**RE: 57-61 Archer Street & 34 Albert Avenue Chatswood – Mixed Use Development  
Traffic and Transport - Response to Submission Letter**

A Transport Impact Assessment (TIA) was submitted as part of a State Significant Development Application (SSD-72891212) for the proposed infill affordable housing development at 57-61 Archer Street Chatswood<sup>1</sup>.

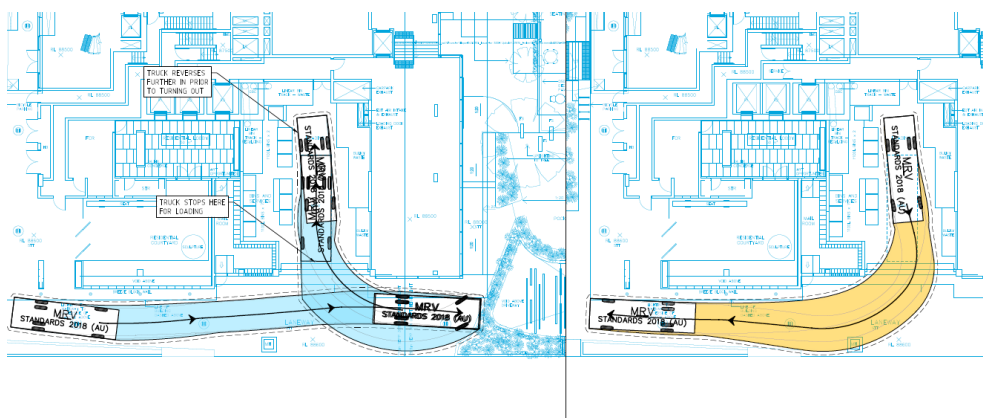
Comment 5 (c) *Ensure the development has been designed to allow for the size and maneuverability of Council's waste vehicle (10.5m length and 4.5m clearance)*

Comment 5 (d) *Demonstrate and provide plans if necessary, that the ground floor service vehicle bay is functional and safe, noting the swept path analysis indicates the width of the bay leaves very little room for vehicle maneuvering and there is very little space for loading/unloading of a vehicle when parked.*

Response: The building management will appoint/hire a private contractor for waste collection. The service area/waste collection area is designed for vehicles up to 8.8-metre medium rigid vehicles (MRV). No vehicles/trucks more than an MRV will require accessing the site and service area. The service area has necessary height clearance of 4.5m for MRV waste truck to access and operate.

The swept path analysis shows that the service area is to accommodate service trucks up to 8.8m long (MRV). The plan also provides sufficient clearance for garbage collection after stopped as per standard. Any vehicle larger than an MRV will detrimentally impact the ground floor plane and significantly reduce amenity of the building.

Response: As shown in above swept path analysis, the service area can accommodate a medium rigid truck (up to 8.8m long) fully within the site. All service vehicles will park within the designated bay (as marked on the plan) and leave sufficient space/clearance (2.5m) on the rear side for loading and unloading. All service vehicles/waste trucks (8.8m) will be able exit in forward direction as shown.
